Access Compliance Report

Public Rights-of-Way

Intersection ID: 10023159	Main Street: CHARLOTTE_VIEW_DR	Cross Street: N/A	Location: NW
ADA ID: DD66C46A4E0F	Ramp Type: PerpDiag	Initial Pass/Fail: Fail	Overall Compliance: No
Codes/Mitigation Info/Possible Solution		Field Measurements/Component Compliance

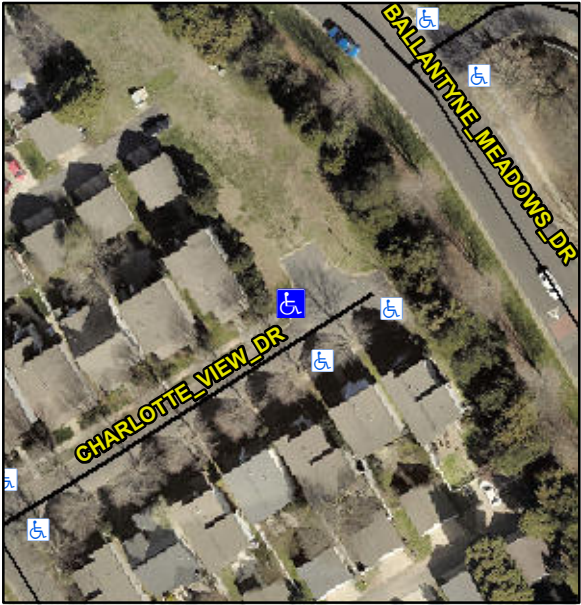
Compliance	Description	Data	Compliance	Description	Data
N/A	Ramp Length (in)	40.0	No	Ramp Slope (%)	10.7
Yes	Ramp Width (in)	48.0	Yes	Ramp XSlope (%)	1.9
N/A	Flare Type LT	N/A	N/A	Flare Type RT	N/A
N/A	Flare Slope LT (%)	N/A	N/A	Flare Slope RT (%)	N/A
N/A	Flare Traversable LT?	N/A	N/A	Flare Traversable RT?	N/A
N/A	Landing Length (in)	N/A	N/A	DWS Provided?	N/A
N/A	Landing Width (in)	N/A	N/A	DWS Contrast?	N/A
N/A	Landing Slope (%)	N/A	N/A	DWS Length (in)	N/A
N/A	Landing X Slope (%)	N/A	N/A	DWS Full Width?	N/A
N/A	Landing Curb? (Y/N)	N/A	N/A	DWS Offset (in)	N/A
N/A	Shared Landing?	N/A			
N/A	Gutter Ponding?	N/A	N/A	Gutter Slope (%)	N/A
N/A	Gutter Lip Ht (in)	N/A	N/A	Gutter X Slope (%)	N/A
N/A	Painted X Walk1?	No	N/A	Painted X Walk2?	No
	X Walk 1 Direction	To SE		X Walk 2 Direction	To NE
N/A	X Walk 1 Width (in)	N/A	N/A	X Walk 2 Width (in)	N/A
	X Walk 1 Slope (%)	1.3		X Walk 2 Slope (%)	2.8
	X Walk 1 X Slope (%)	2.6		X Walk 2 X Slope (%)	0.6

N/A	Ramp inside XWalk1?	N/A	N/A	Ramp inside XWalk2?	N/A
	Road Slope (%)	2.2	N/A	Clear Space?	N/A
	Road X Slope (%)	2.8	N/A	Clear Space to XWalk (in)	N/A
N/A	Any Obstructions?	N/A	N/A	Storm Grate/Utility Hazard?	N/A
	Obstruction Type			Storm Grate/Utility Type	
		N/A			N/A
			Yes	Surface Condition? (G/P)	Good

Possible Solutions:			
	Remove & Replace Curb Ramp With Two New Directional Ramps or Equivalent.			
	Surveyor Notes:			
	N/A			
	PROW/ADA:			
	R304.2.2			
Street 1 Name	CHARLOTTE VIEW DR			
Stop Condition-Street 2	None			
Street 2 Name	N/A			
Stop Condition-Street 1	None			
Total Cost:		\$	3200.00
